Re: Chevron Service Station No. 90076
4265 Foothill Boulevard
Oakland, CA

Re: Updated Site Plan
Chevron Service Station 90076
4265 Foothill Boulevard
Oakland, California
Fuel Leak Case No. RO0000427

Subject: LTCP Review and Work Plan Addendum Request; Fuel Leak Case No. RO0000427 and GeoTracker Global ID T0600100339, Chevron #9-0076, 4265 Foothill Blvd, Oakland, CA 94601

Figure 2
 SITE PLAN
 CHEVRON SERVICE STATION 90076
 4265 FOOTHILL BOULEVARD
 Oakland, California

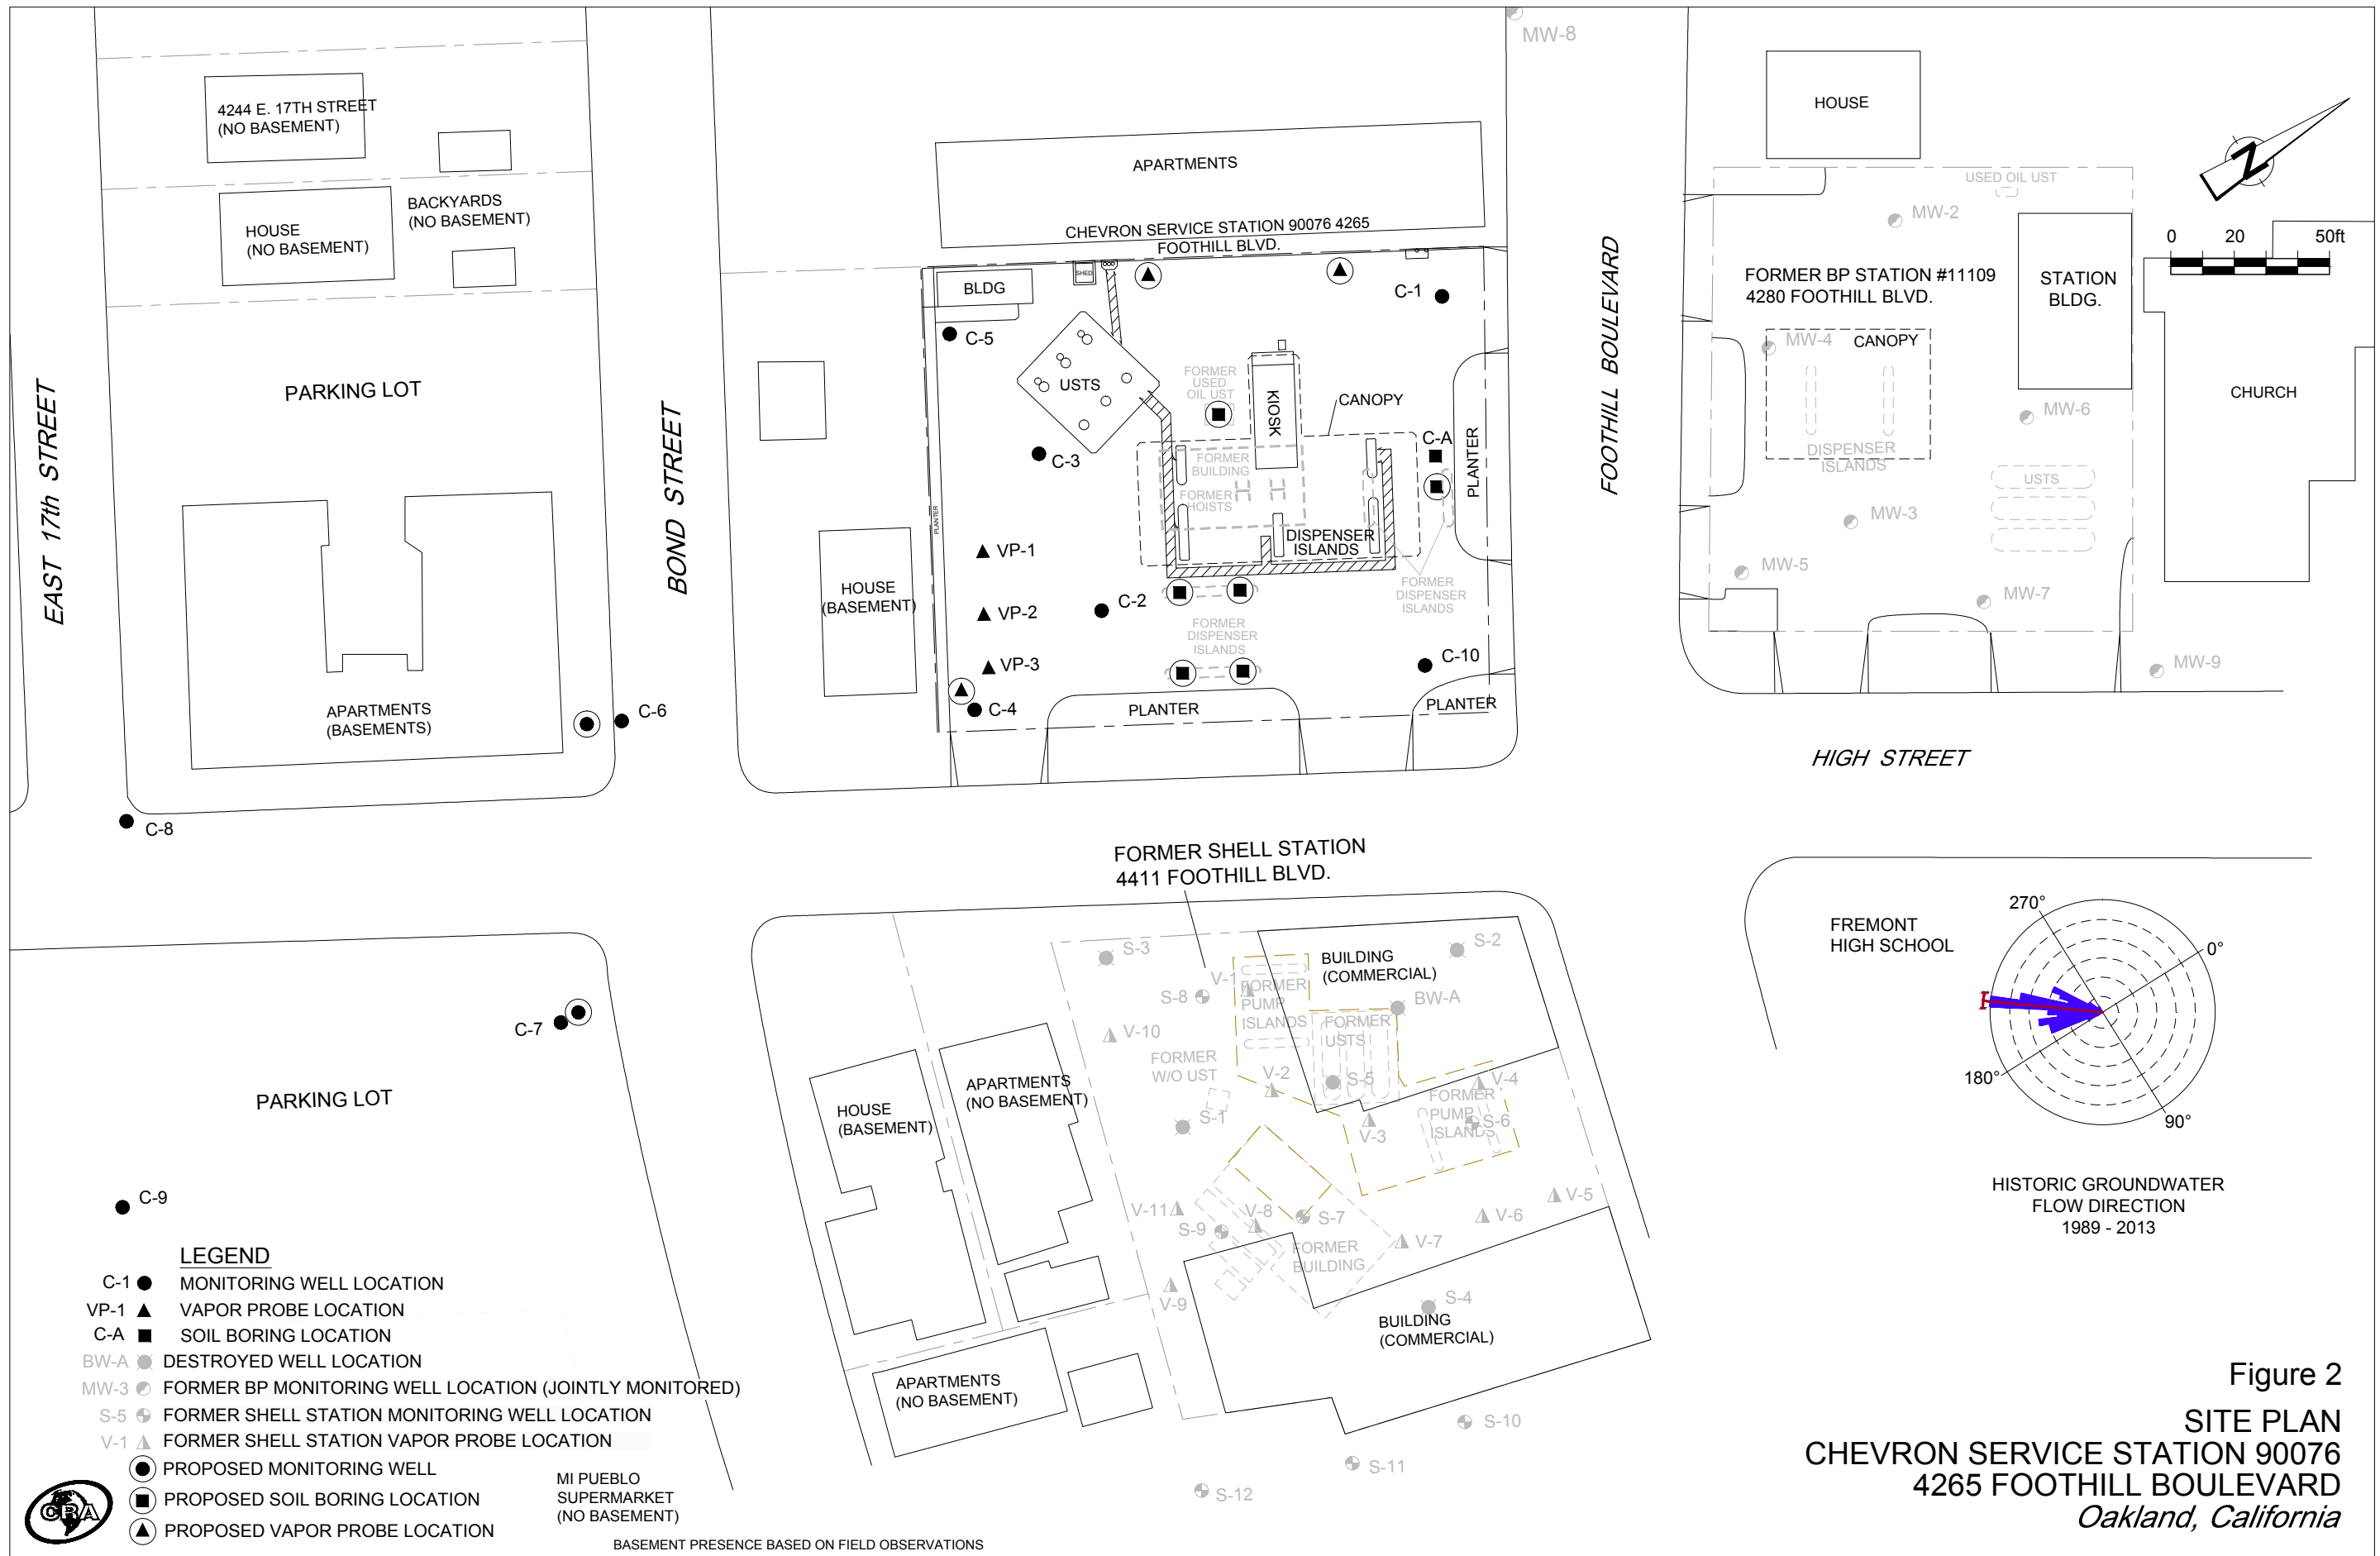
Conestoga-Rovers & Associates (CRA) is submitting this correspondence on behalf of Chevron Environmental Management Company (CEMC) for former Chevron Station 90076 located at 4265 Foothill Boulevard, Oakland, California (Figure 1). In a letter dated November 21, 2013 (Attachment A), Alameda County Environmental Health Services (ACEH) requested Chevron submit work plan modifications to CRA's September 14, 2012 *Soil Vapor Sampling, Preferential Pathway Study, and Work Plan*. However, as discussed during the April 24, 2014 meeting between CRA, CEMC, and ACEH, CRA is submitting an updated site plan with former dispenser island locations, and proposed locations of six soil borings, two shallow groundwater monitoring wells, and three vapor probes. The borings, wells, and probes will be installed and sampled as proposed in the September 2012 *Work Plan*.
